World Forum for Harmonization of Vehicle Regulations

Proposal for a new supplement to the original version and the 01 series of amendments to UN Regulation No. 154 (Worldwide harmonized Light vehicles Test Procedures (WLTP))

Submitted by the expert from the International Organization of Motor Vehicle Manufacturers*

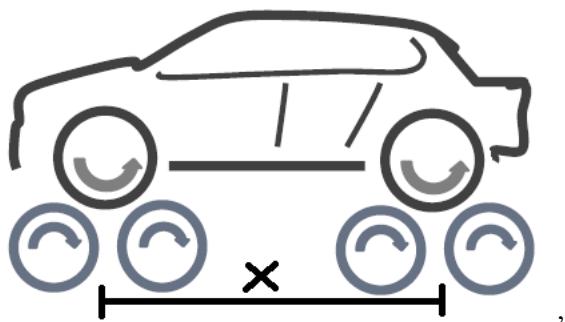
"2.3.1.3. The usage of twin roller dynamometers with 4WD configuration should be accepted if the following conditions are met:

- (a) **The separation distance between the front and rear sets of twin rollers of the dynamometer (X in diagram below) is set as closely as possible to match the manufacturer's declared wheelbase of the vehicle to be tested, and**
- (b) **It shall be ensured that the setting of the separation distance between the roller sets used for dyno load setting is reproduced for vehicle testing.**
